RE: Lot 2 Elm Grove Villa - Smith Plumbing & Heating; Water Quality Detention Pond Certification

Lot 2 Elm Grove Villa
Water Quality Detention Pond Certification
April 8, 2024

DETENTION BASIN STAGE-STORAGE TABLE BUILDER

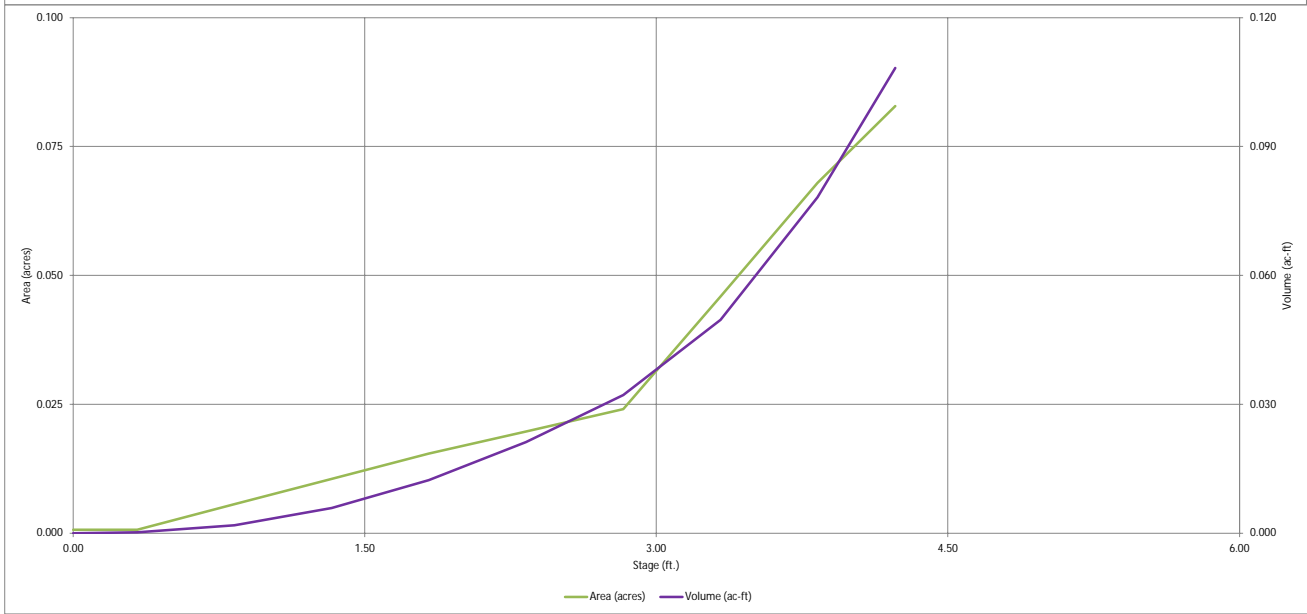
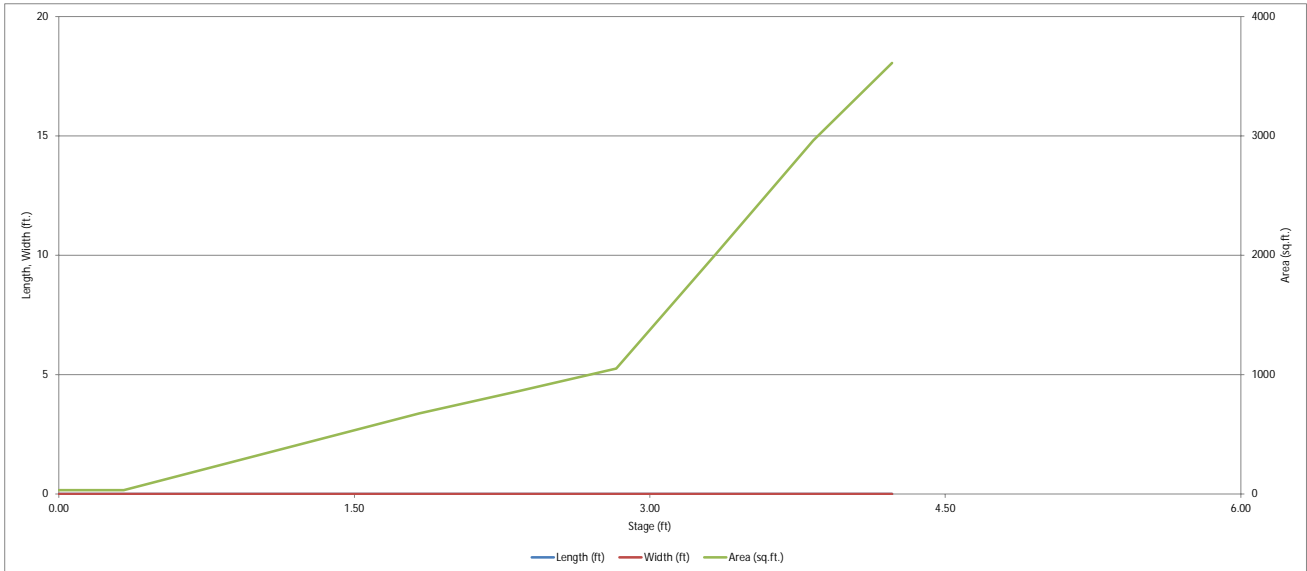
Revise/provide Pond Certification Letter with required statements listed in ECM Section 5.10.6.B:

"The site and adjacent properties (as affected by work performed under the County permit) are stable with respect to settlement and subsidence, sloughing of cut and fill slopes, revegetation or other ground cover, and that the improvements (public improvements, common development improvements, site grading and paving) meet or exceed the minimum design requirements."

For sites including detention and/or water quality facilities, the certification letter shall include a statement that the facilities provide the required storage volume and will meet the required release rates (as documented by an attached MHFD design form), the stage areas, elevations, and outlet dimensions.

ORFICE PLATE DETAIL

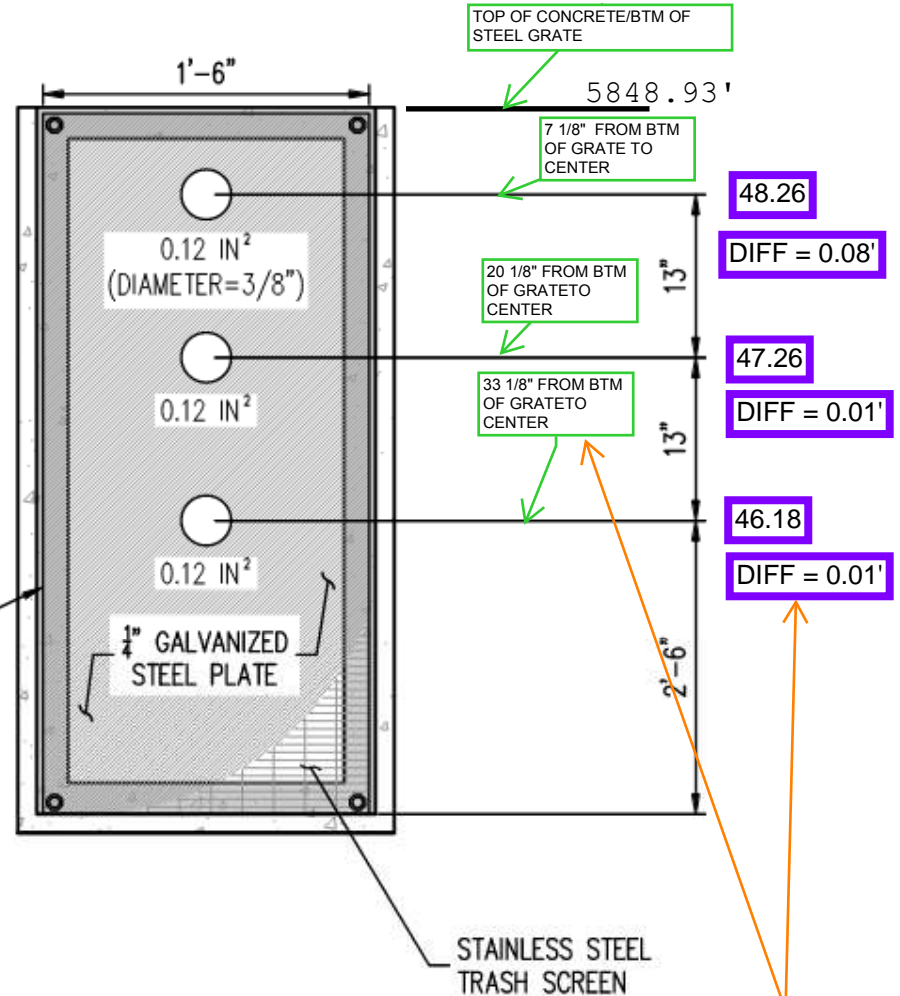
Clarify what "BAS" means. Because the first page of the letter above states that the pond survey was completed by Ridge Line Land Surveying.

To avoid confusion, label the date that this survey data is from to clarify that the blue data is more recent - to show that the plate was modified since this red data was taken.

Or better yet, just delete all of this red data since it is not representative of the as-built condition.

Please copy all of these green and blue text boxes over to the detail on the previous page or overlay a screenshot of this page on top of the same detail on the previous page.
